To: Membership of X3T10

From: Ralph O. Weber           ROWeber@ACM.org  
      ENDL Associates

Date: July 16, 1995

Subject: Proposed REPORT LUNS command

Table n1 - REPORT LUNS command

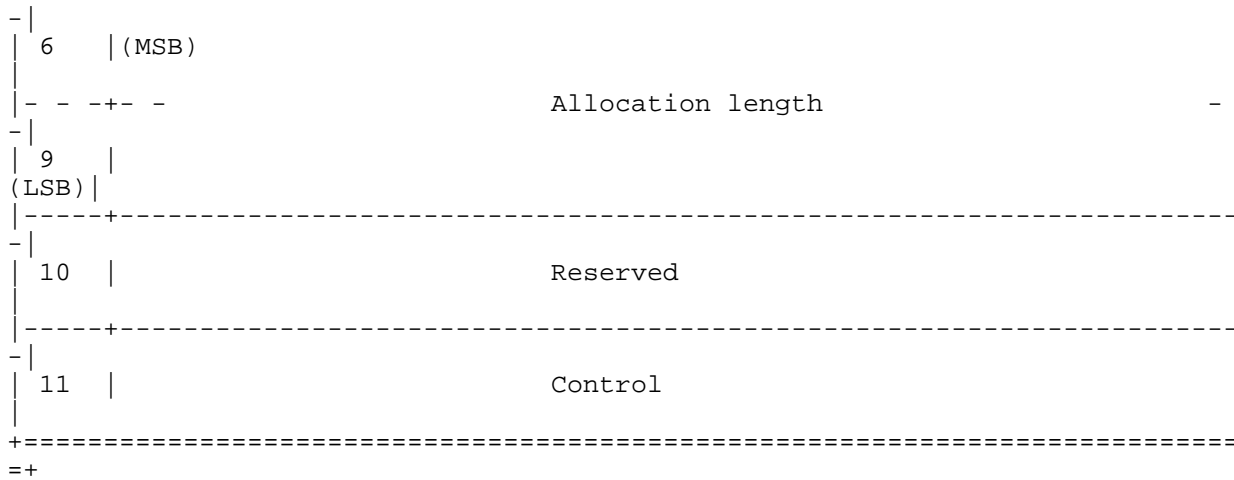
The REPORT LUNS command (see table n1) requests that the logical unit numbers of known peripheral logical units at the target be sent to the application client. The REPORT LUNS command shall return information about only those logical units to which commands can be sent.

The Allocation length shall be at least 16 bytes. If the Allocation length is less than 16 bytes, the device server shall return CHECK CONDITION status. The sense key shall be set to ILLEGAL REQUEST and the additional sense data shall be set to INVALID FIELD IN CDB.

The Allocation length may not be sufficient to contain the logical unit number values for all configured logical units. This shall not be considered an error. The device server shall report as many logical unit number values as will fit in the specified Allocation length.
